Re: Rapiscan AIT System Radiation Survey Reporting

Rapiscan systems <small>AN ISO SYSTEMS COMPANY</small>	Secure 1000 Radiation Emission Measurement	FORM R-0646-1 (Single Pose)
---	---	--------------------------------

**R-0646-1 Addendum
(Documentation Errors)**

1. In Beam Dose Measurement: Survey Table. 1

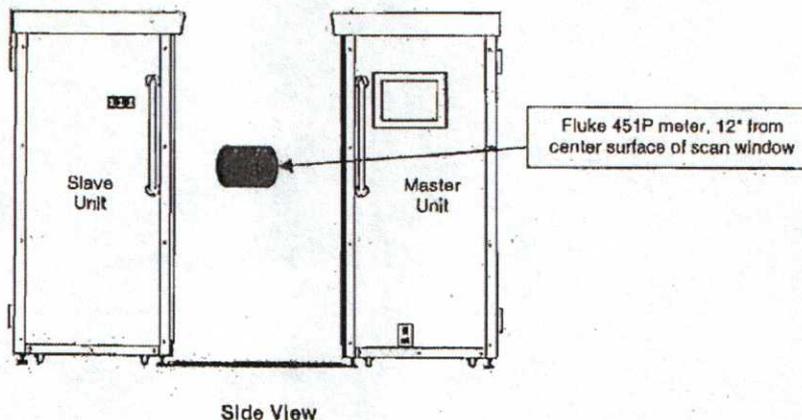
1. No value indicated for background radiation. Typical values range from 7uRem/hr to 13uRem/hr at sea level. Note: Absence of value has no adverse impact on calculations.
2. Technician indicated scan time as 7 seconds. Correct scan time is 3 seconds.
3. TABLE 1: Incorrect presentation of data in Column 3 for Measured Exposure. Indicated values are 39uR and 40uR. Corrected values are 3.9uR and 4.0uR. The values were corrected by technician when calculating Effective Dose.

The service technician should attend refresher training.
